To: City of the Village of Douglas Planning Commission
Date: February 1, 2024
From: Sean Homyen, Deputy Clerk
RE: 111 Wall St. Special Land Use – Residential Use of an Accessory Building

Thomas and Liana Allison, property owners, have submitted an application for Special Land Use review for the Residential Use of an Accessory Building, per Section. 26.31 of the City of the Village of Douglas Zoning Ordinance on a parcel of land described as Parcel No. 59-551-005-00, located at 111 Wall Street in the R-3, Neighborhood Conservation District. The parcel is also described as lot 5 of Spencer’s Addition plat. The subject parcel is generally located on the south side of an unimproved section of the west end of Wall Street, just west of the Wall Street / Union Street intersection.

Site Plan

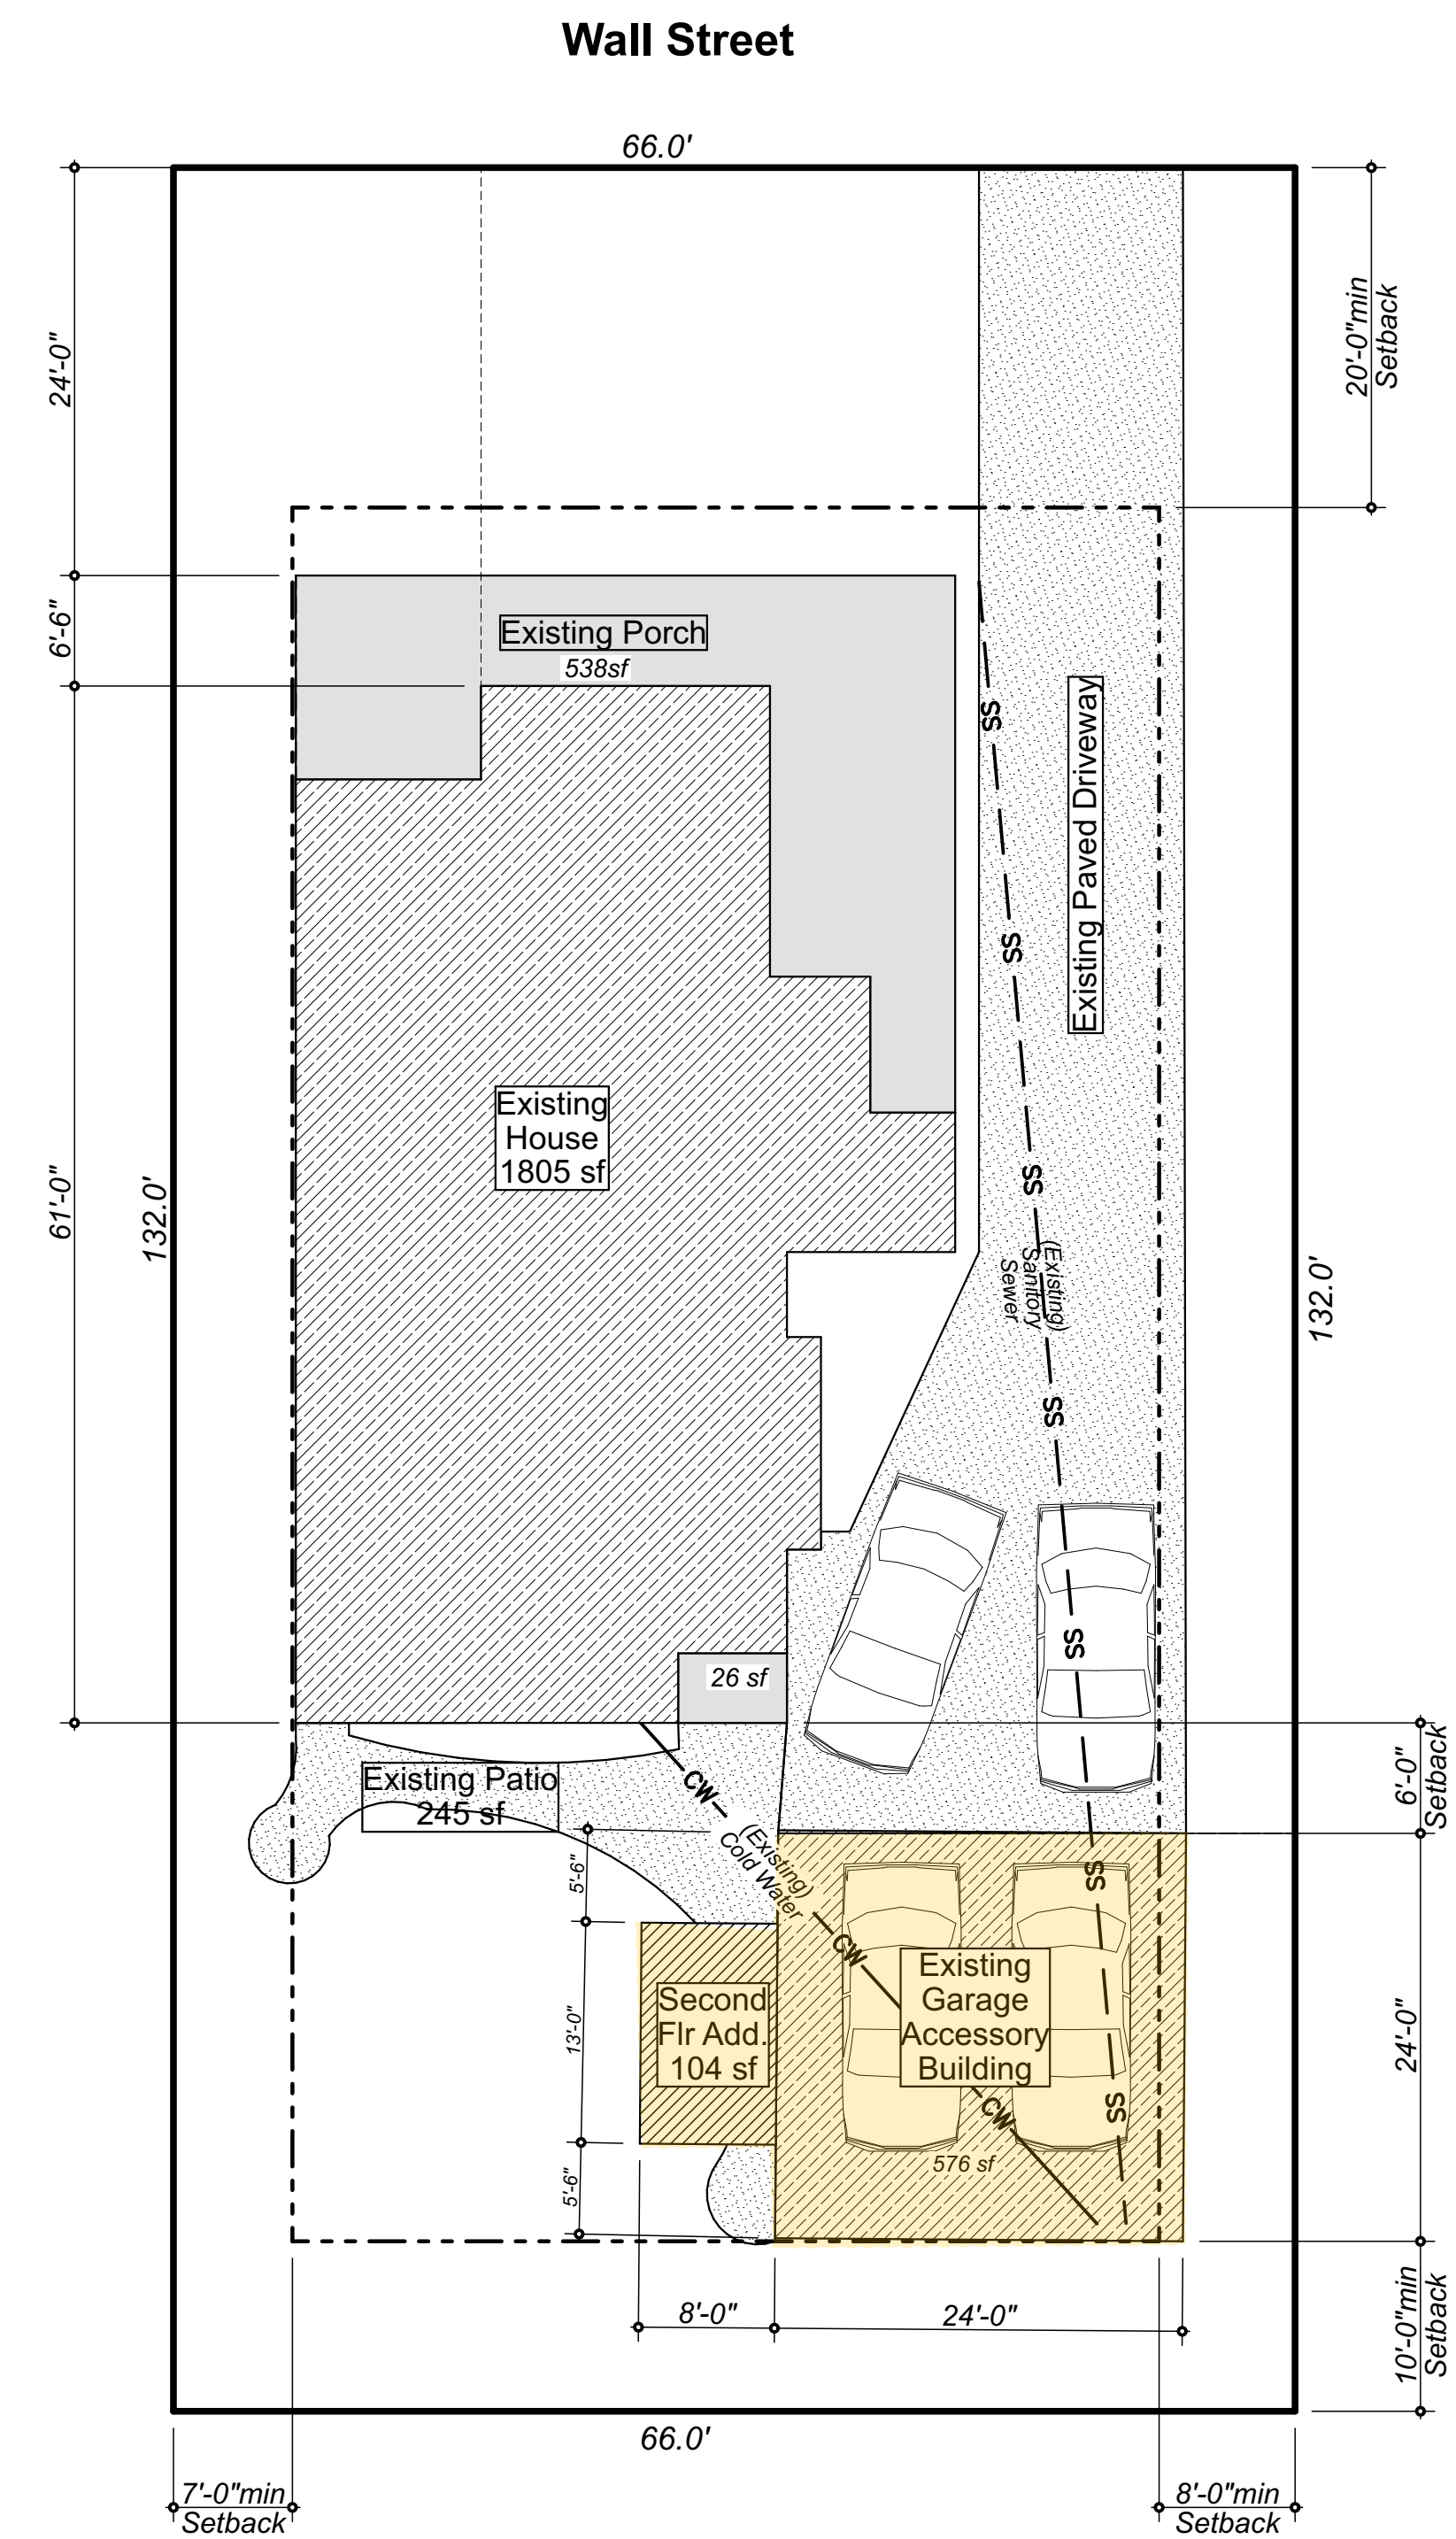
Comment: The principal and accessory structures meet the setback requirements, lot coverage and other lot requirements in Sec 3.12. This is noted on the site plan. This requirement is met.

Comment: The proposed residential area is planned to connect to utilities for water and sanitary sewer. This is shown on the site plan. This requirement is met.

Comment: The Planning Commission may find that this is met. The additional off-street parking spaces are shown on the site plan.
